SUBJECT: CHANGES TO ADMINISTRATIVE CONTROLS SECTION OF TECHNICAL SPECIFICATIONS (TAC 56027, 56028, 56029)

Re: Browns Ferry Nuclear Plant Units 1, 2, and 3

The Commission has issued the enclosed Amendments Nos. 138, 134, and 109 to Facility Operating Licenses Nos. DPR-33, DPR-52, and DPR-68 for the Browns Ferry Nuclear Plant, Units 1, 2, and 3, respectively. These amendments are in response to your application dated September 27, 1984 as supplemented January 17, June 2, and December 10, 1986 (TS-201). Minor changes were made to proposed Specifications 6.5.1.6.b and k, 6.5.3.1 and 6.8.1.1 to clarify the Specifications. These changes were discussed between the Office of Special Projects, Project Managers and Mike May (licensee) on September 8, and September 11, 1987, and accepted by the licensee.

The amendments change the Technical Specifications to show recent organization changes, provide improvements and clarification to the administrative controls section and reformat the administrative controls section to be more in line with Standard Technical Specifications.

Figure 6.2-1 Offsite Organization for Facility Management & Technical Support

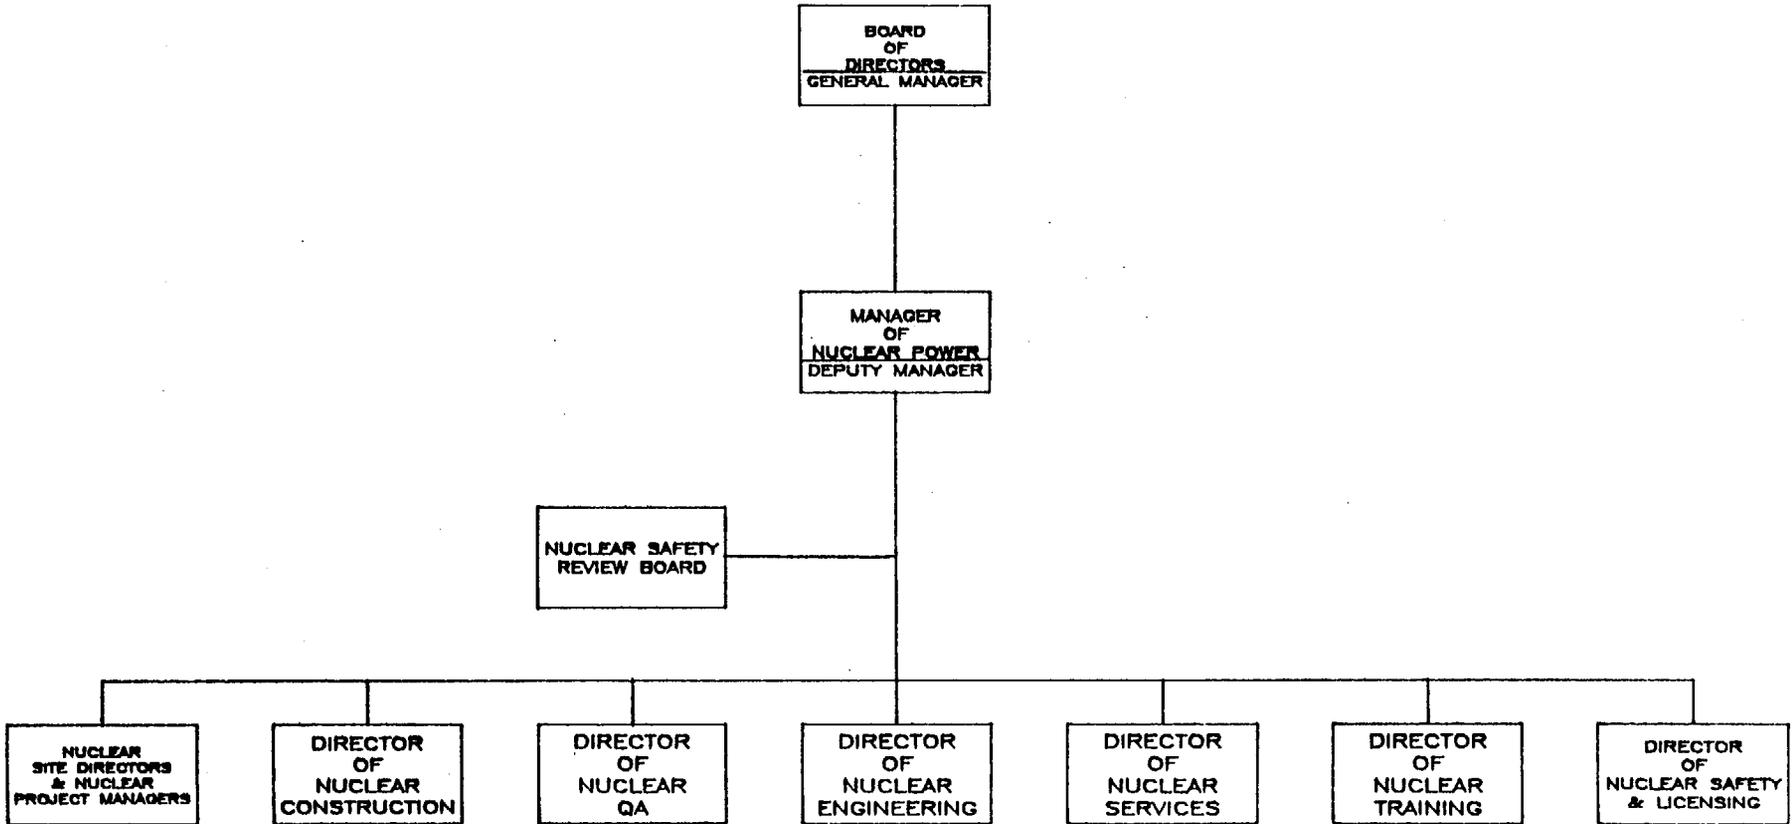
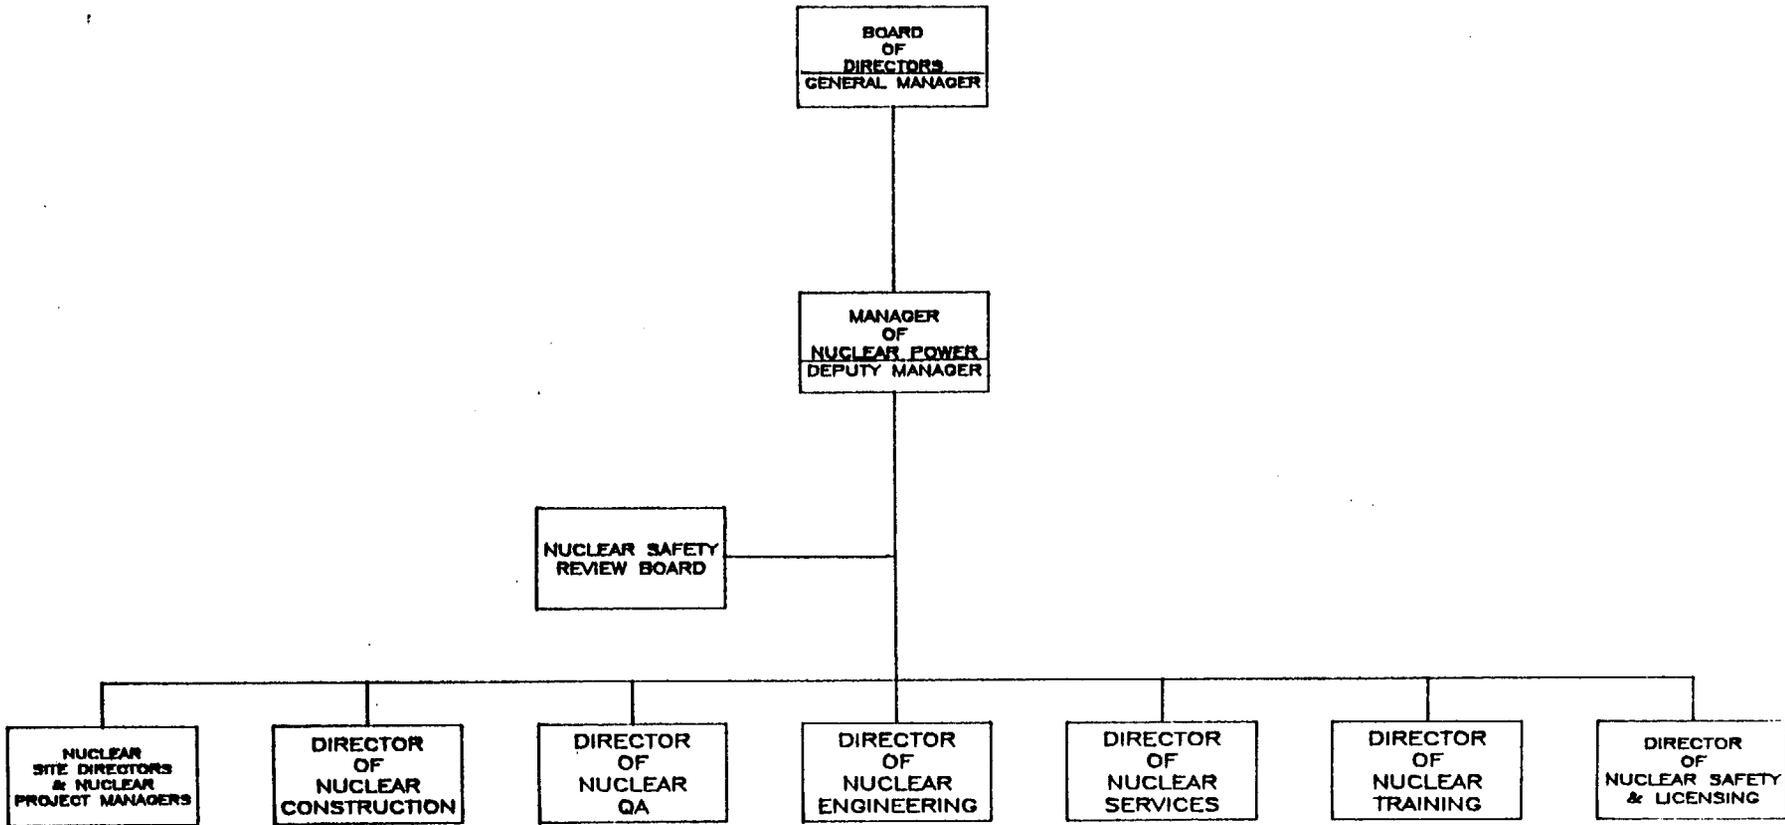
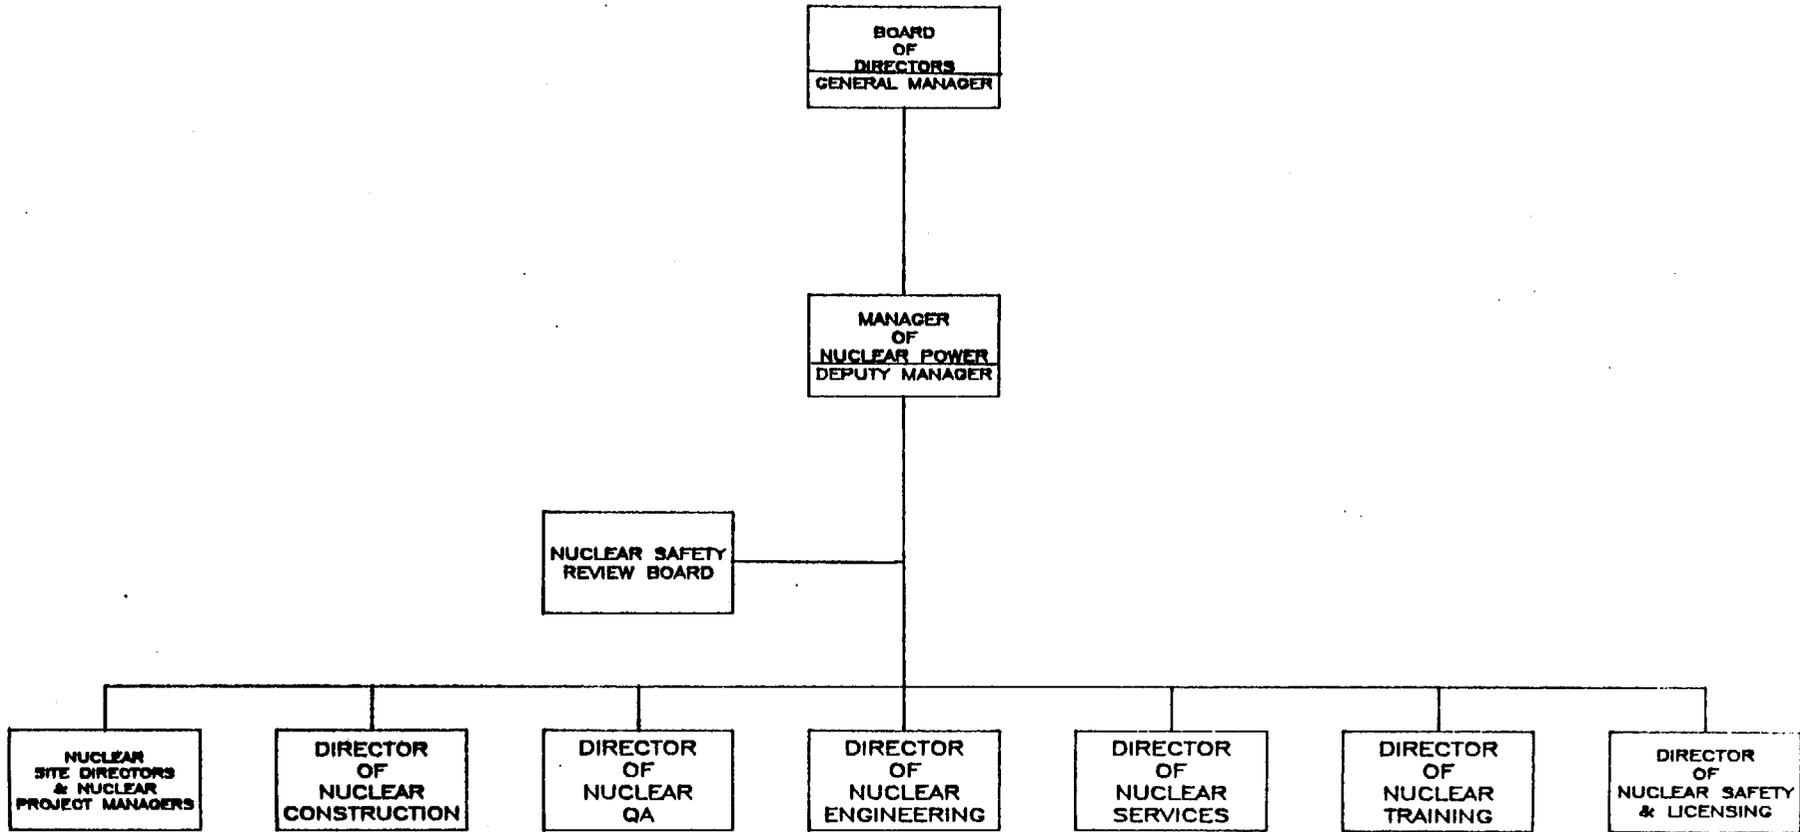
2.3 Revisions to the Offsite Organization Chart, Figure 6.2-1

Figure 6.2-1 has been revised to reflect the TVA corporate offsite nuclear organization for facility management and technical support. The corporate level changes represent a restructuring of the corporate offsite organization to provide for centralized direction and control of nuclear activities. Each of the offsite corporate departments shown in Figure 6.2-1 will be responsible for direct support of the sites in their areas of responsibilities. The TVA corporate organization was developed so that support to each of the sites follows clear lines. The functional alignment of departments within corporate is paralleled at the plant sites (including Browns Ferry).

**FIGURE 6.2-2
 FACILITY ORGANIZATION**

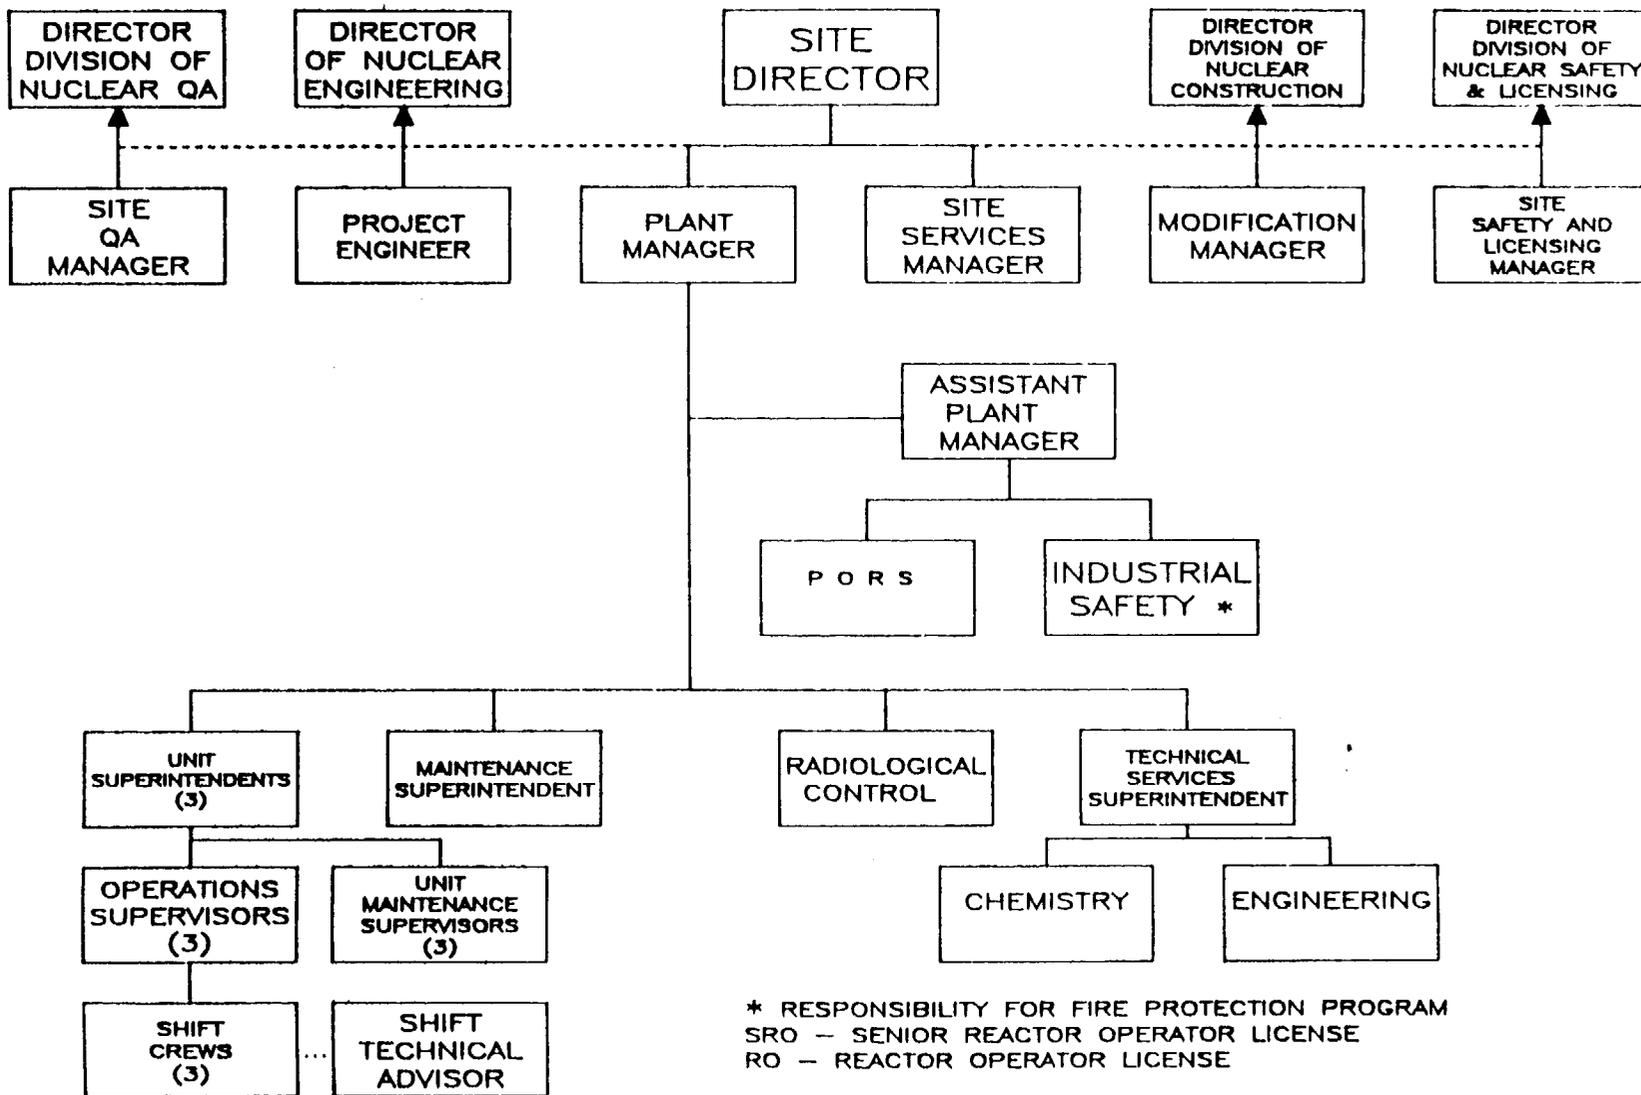
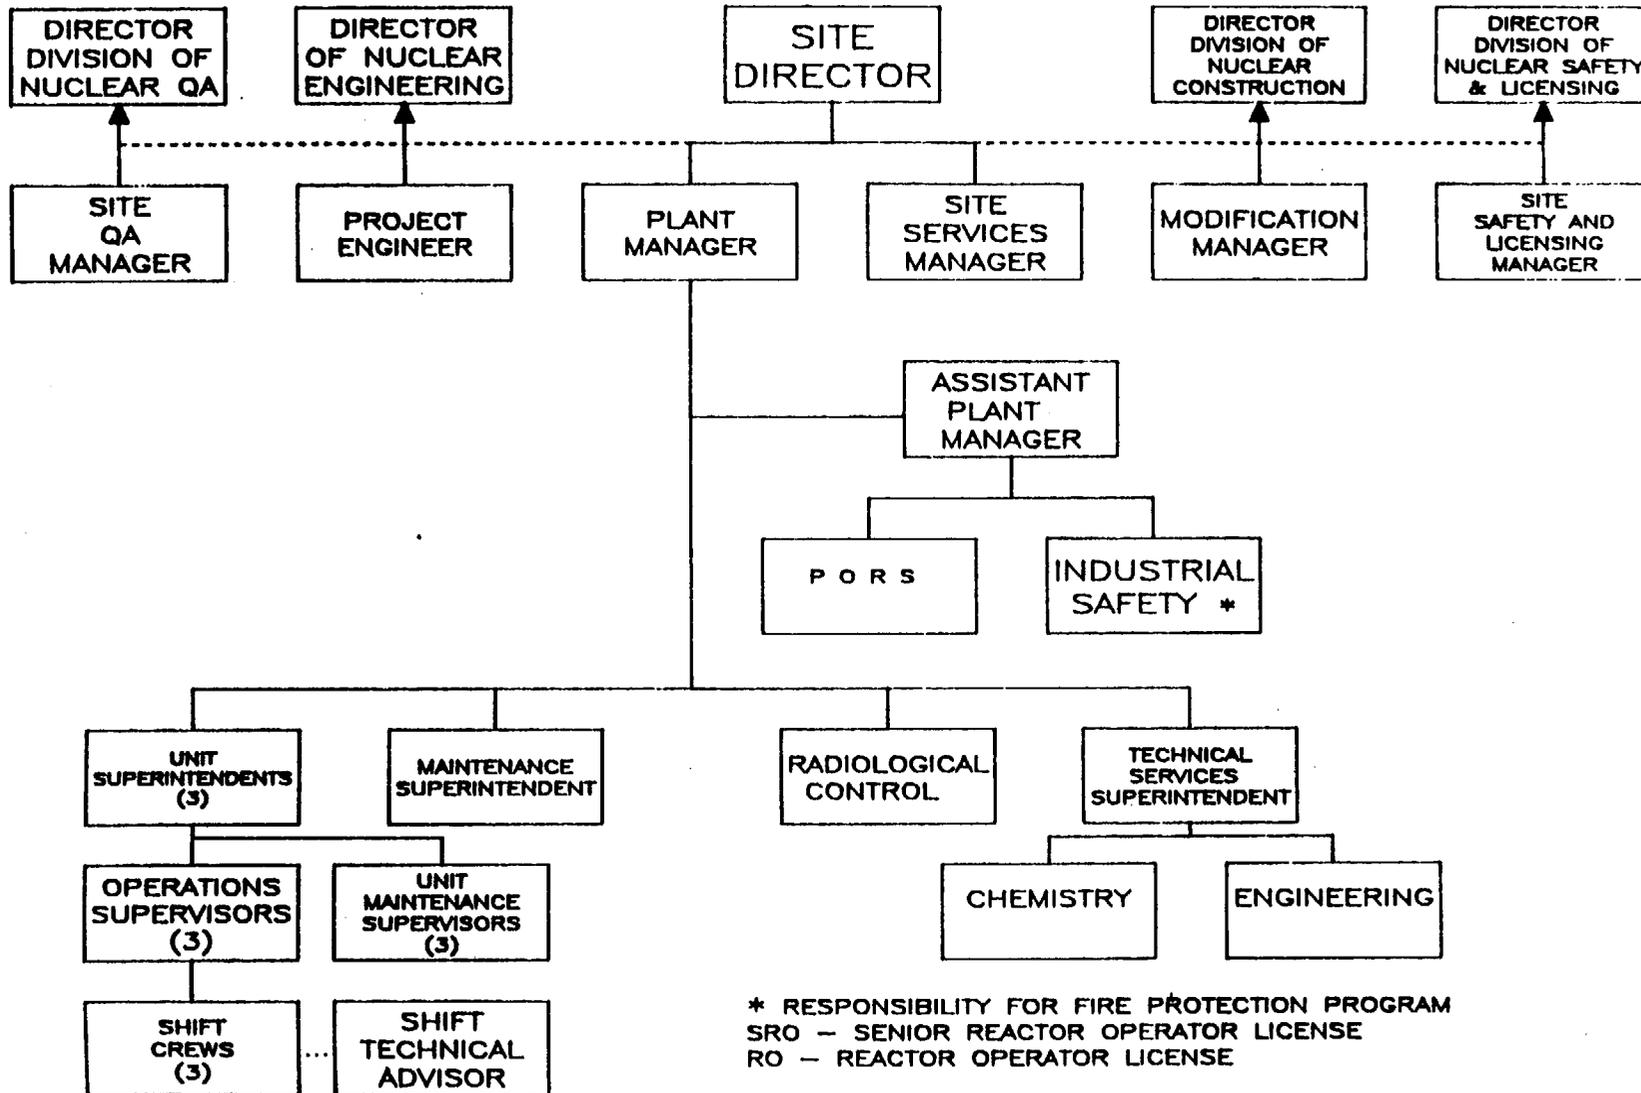
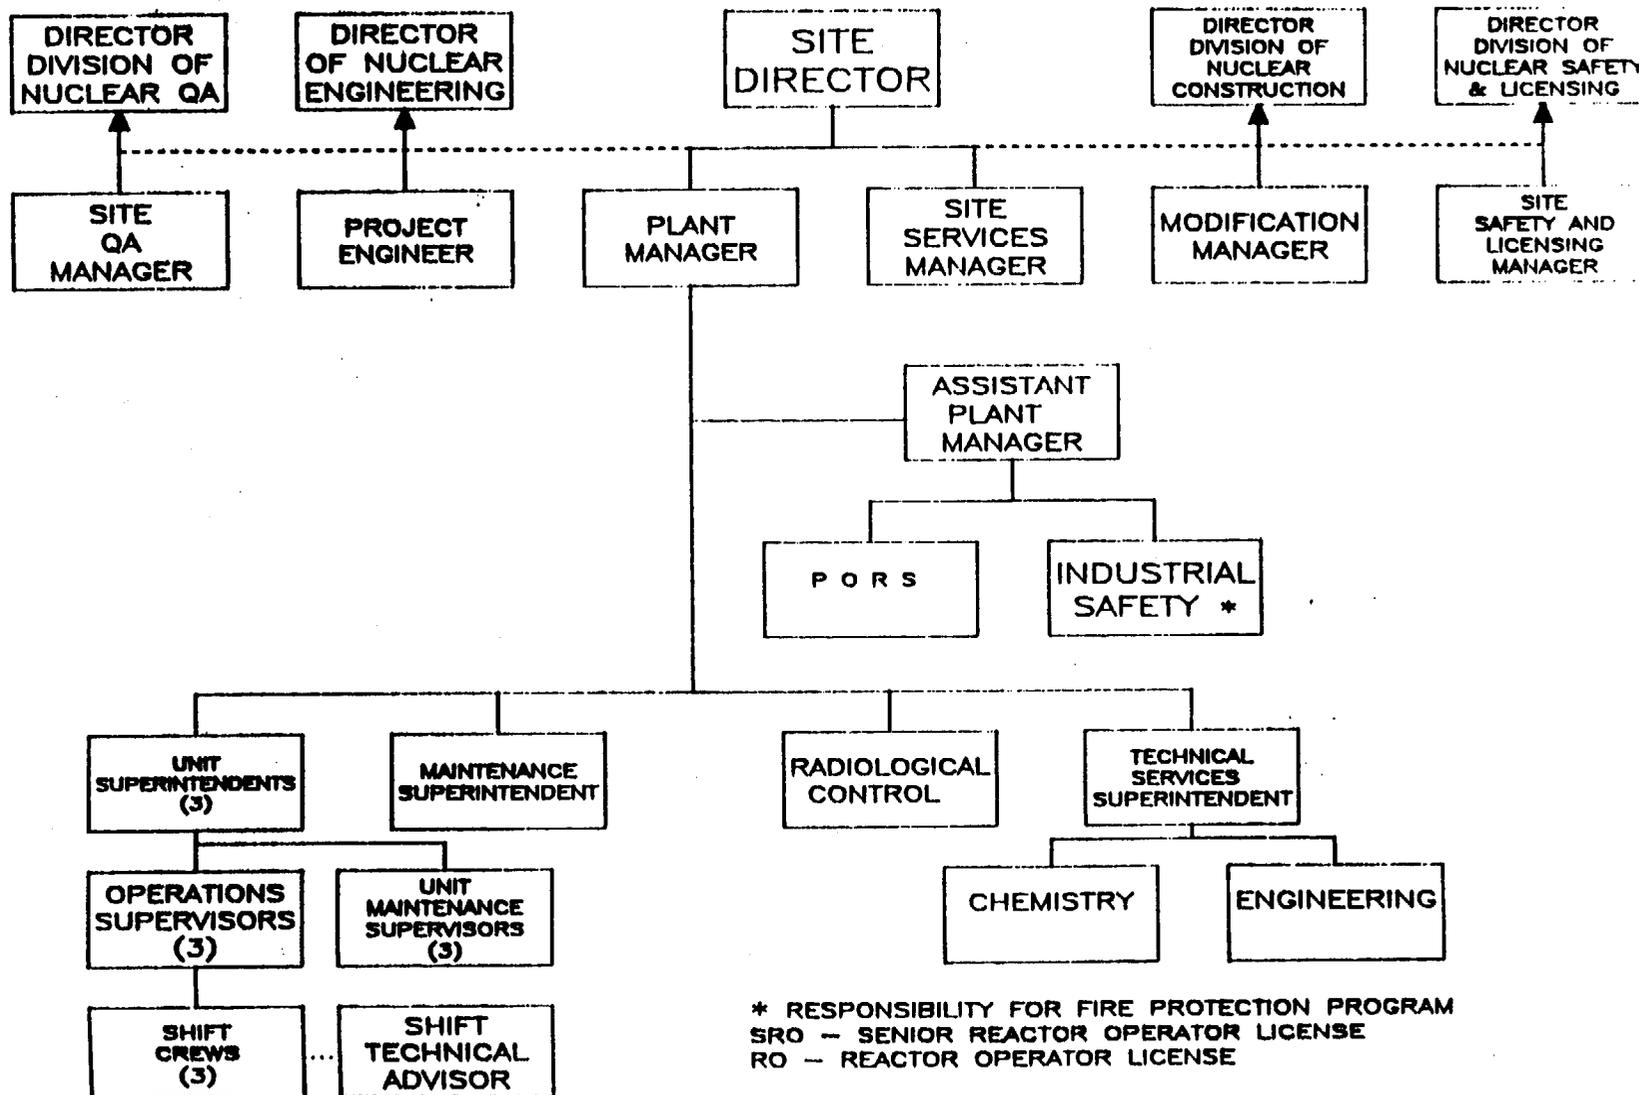
2.4 Revision to the Facility Organization Chart, Figure 6.2-2

Figure 6.2-2 has been revised to reflect the new site organization at the Browns Ferry Nuclear (BFN) Plant as detailed in the latest revision of the Browns Ferry Nuclear Performance Plan (BFNPP), submitted to NRC on July 1, 1987. The BFN site support organizations have been reorganized into functional departments that generally parallel the functional departments in the headquarters of the Office of Nuclear Power. The BFNPP describes the plan for providing management control and performing specific actions to correct past problems at BFN. Specifically, the BFNPP outlines the management approach to overcoming past problems and improving regulatory performance at the BFN. This TS change revises the organization chart in the TS to be consistent with the organization necessary to carry out the improvements specified in the BFNPP.

In conclusion, Figure 6.2-2 represents the BFN organization which (1) reflects an increase in staffing, (2) provides a higher level of management control at the site, (3) shows improved management involvement in plant operations, (4) has distinct functional areas that are separately supervised, (5) meets the acceptance criteria of Section 13.1.2 of the SRP, and (6) is consistent with the BFN organizational structure presented in the BFNPP. Therefore, Figure 6.2-2 is acceptable.
